IEEE 802.1CB Maintenance Item 0343

Differences in the interaction of
Stream Identification with
PSFP&ATS vs. FRER

Port Interface References

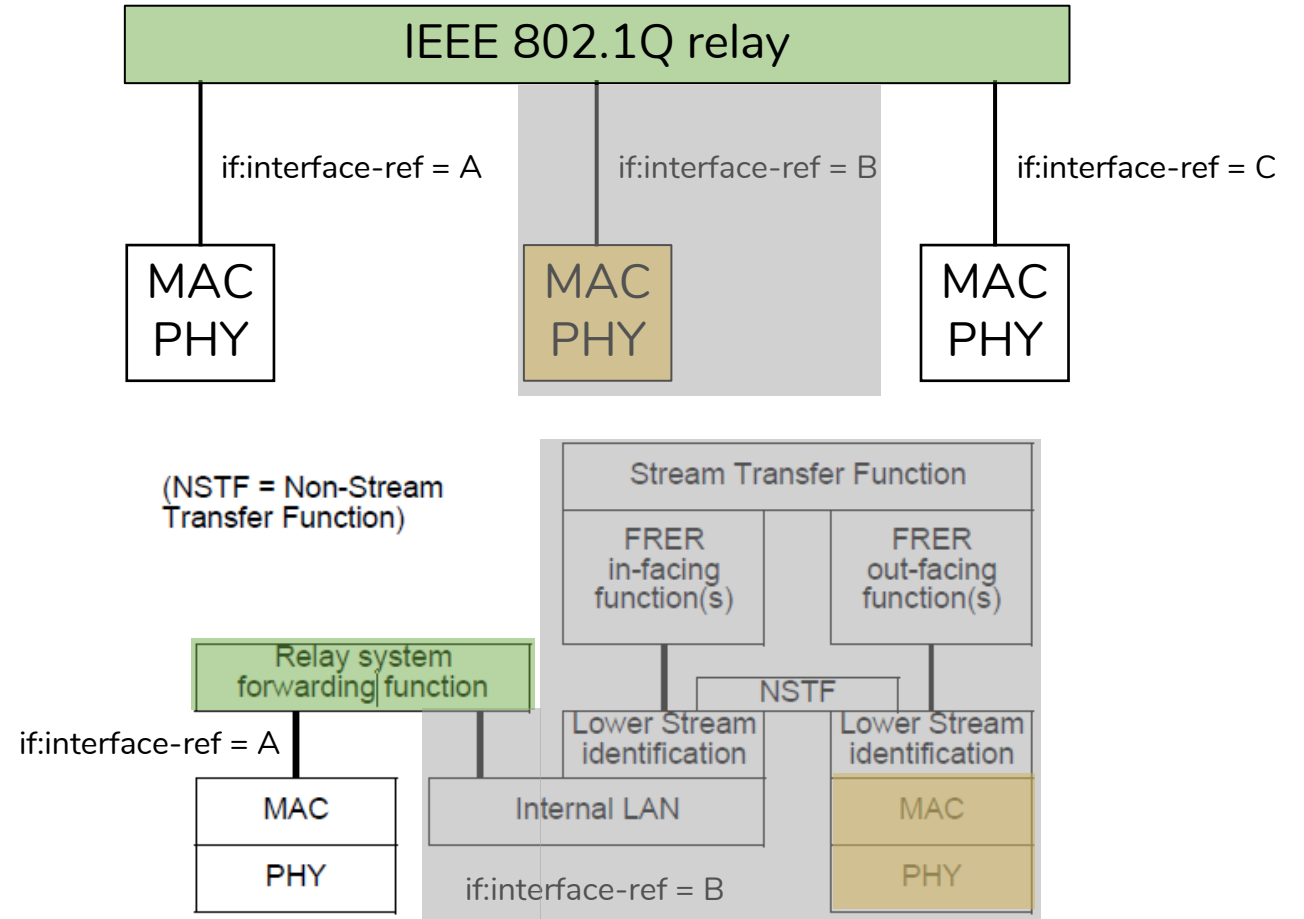
- IEEE 802.1CBcv-2021 uses if:interface-refs to attach Stream Identification Functions to Ports.
- While in a Stack Model view, the interface may seem “split up”, it is in fact not.
- While in a Stack Model view there is a sequence of entities implied, this is actually not strictly mandated.

Passive Stream Identification does nothing on DOWN path

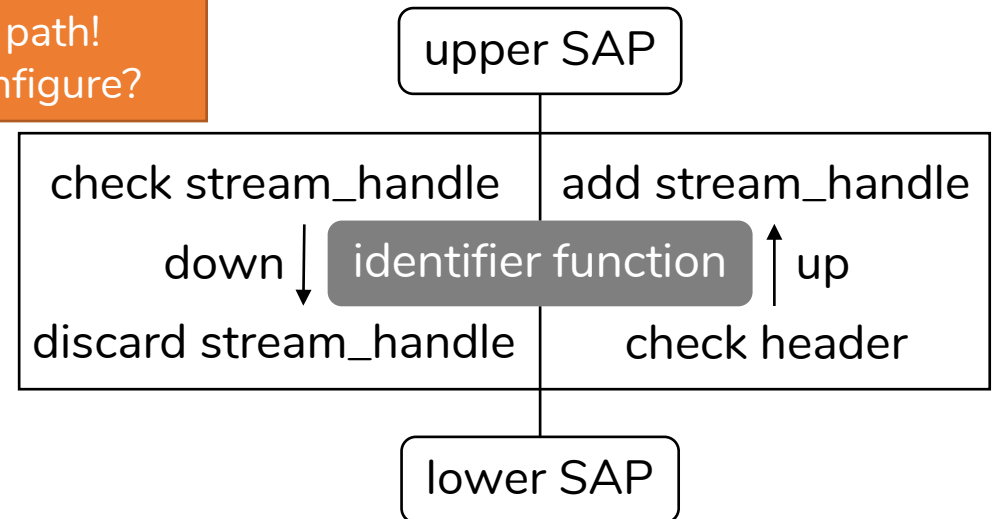
Basically do NOTHING on the DOWN path!
Why even configure?

- 6.4 Null Stream identification
- 6.5 Source MAC and VLAN Stream identification
- 6.7 IP Stream identification
- 6.8 Mask-and-match Stream identification

all state:

“... discards the stream_handle subparameter for packets passed down the stack.”

no statement for

6.6 Active Destination MAC and VLAN Stream identification

Active Stream Identification

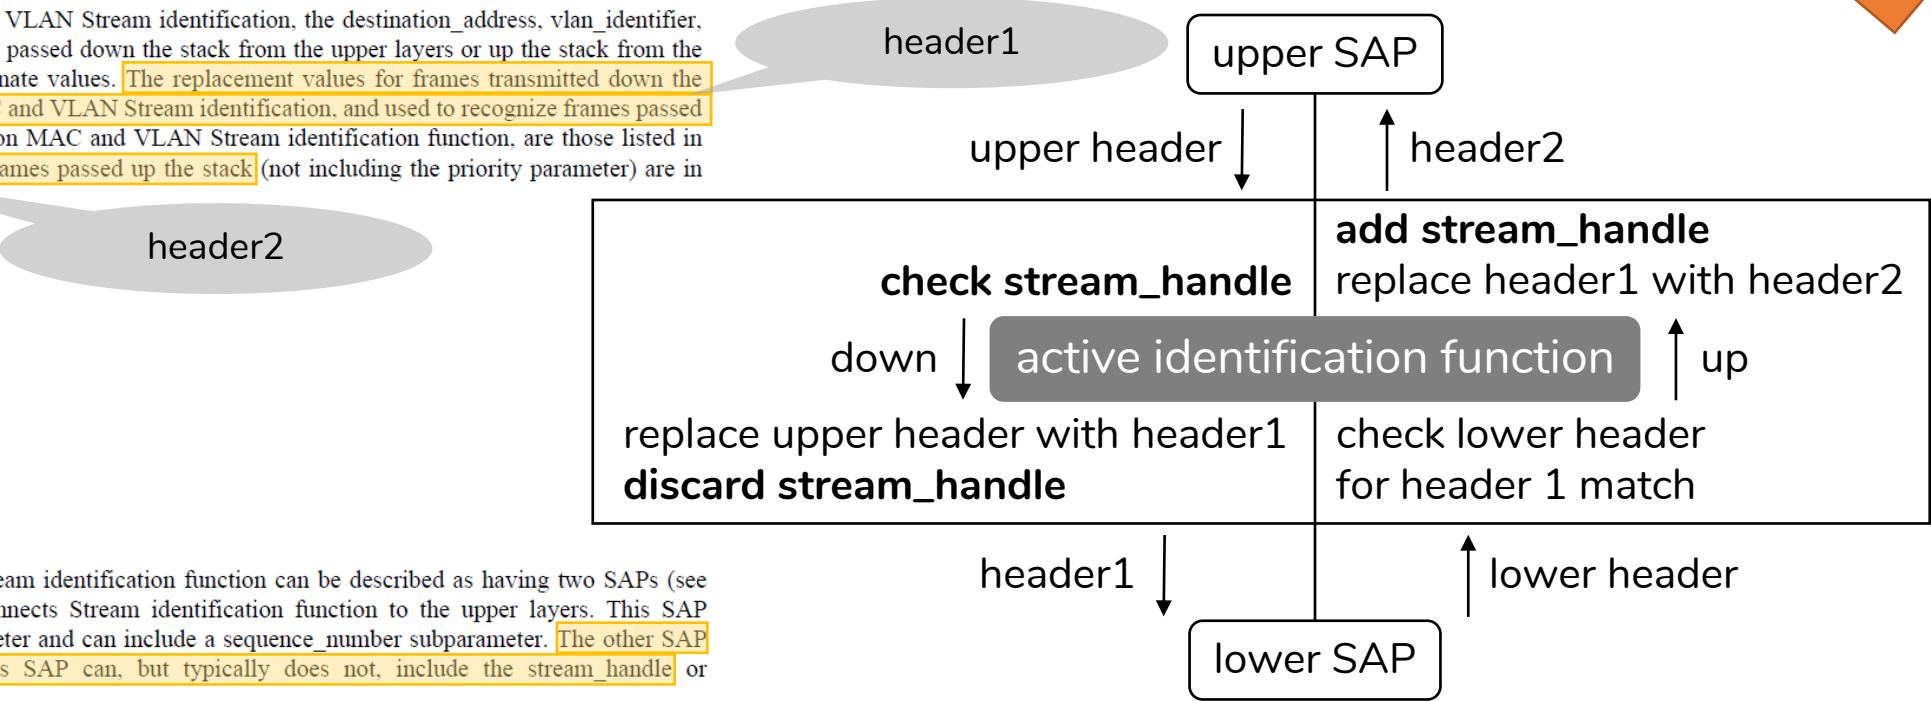
... also practically: "... discards the stream_handle subparameter for packets passed down the stack."

Ambiguity of 2 Out-Facing Functions

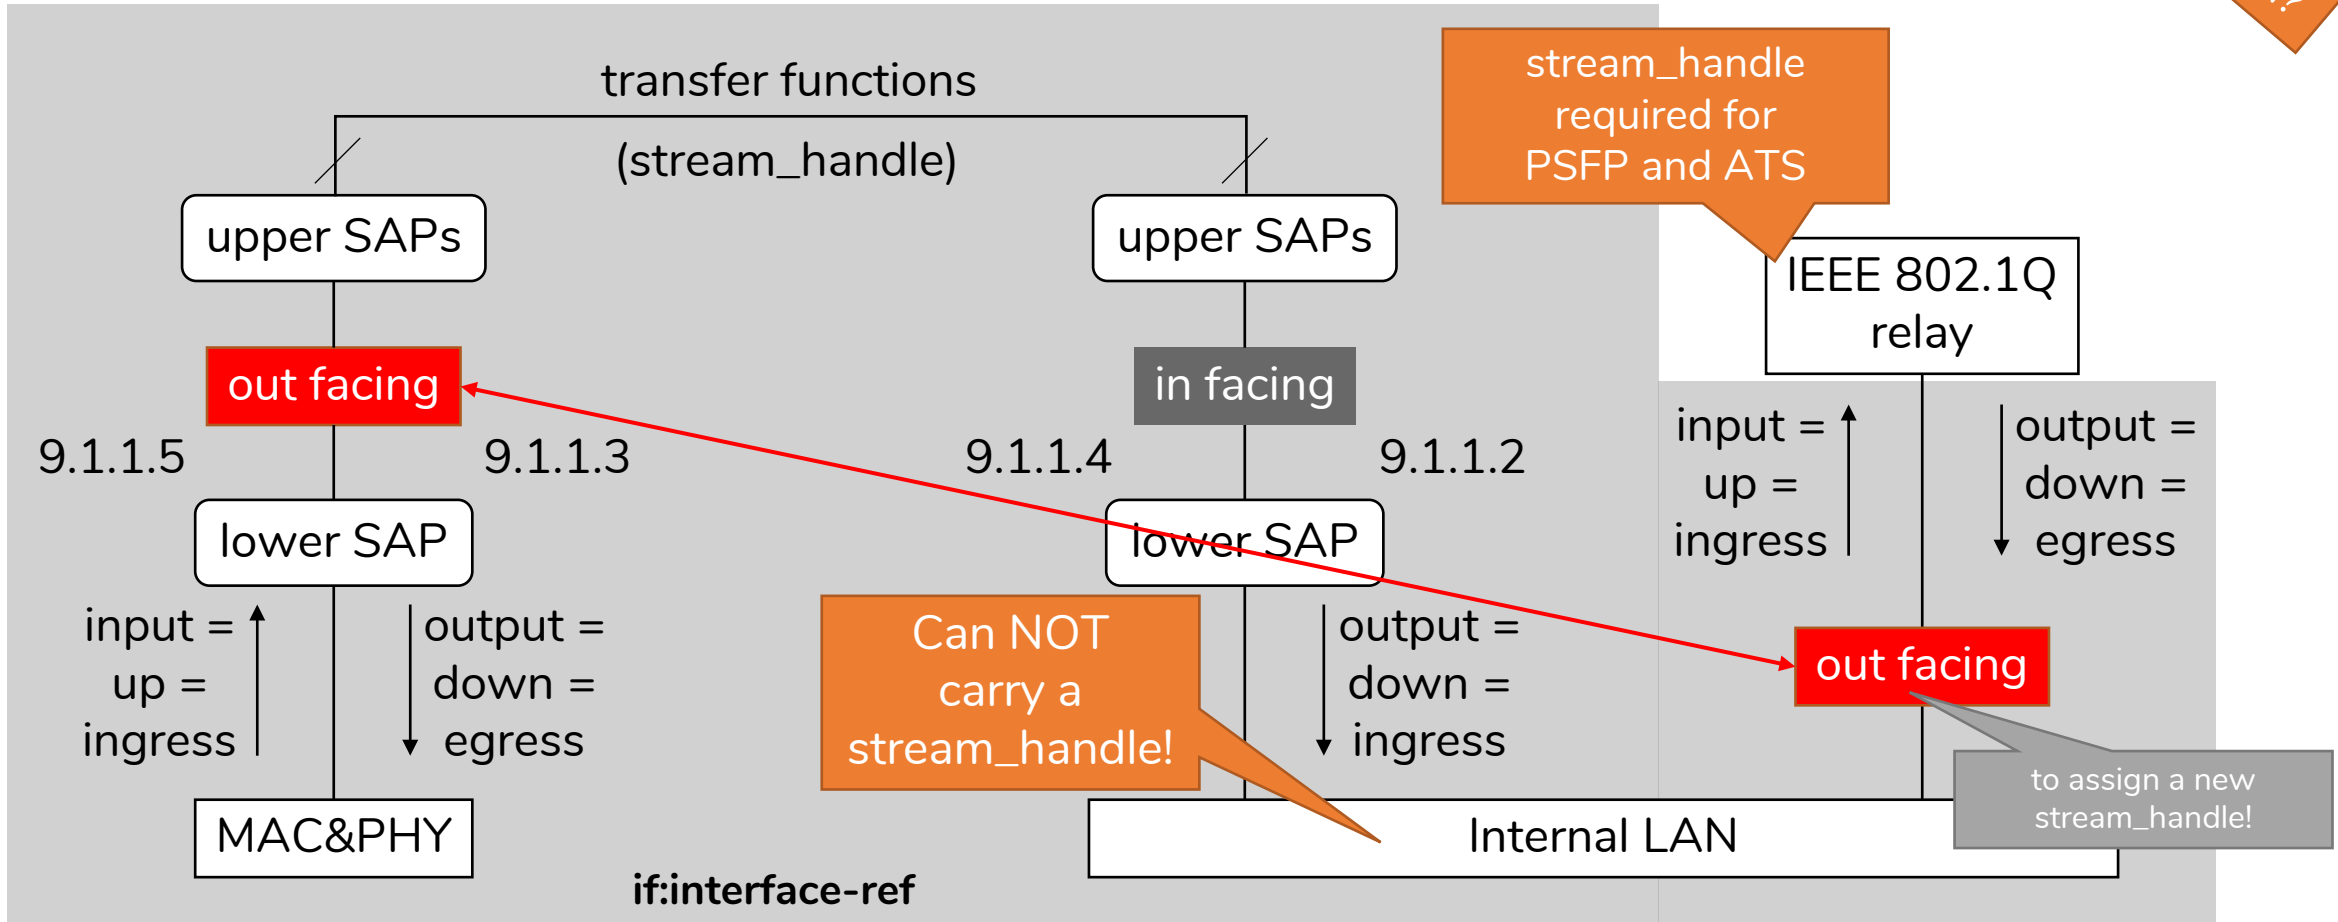
NEW Maintenance Item?
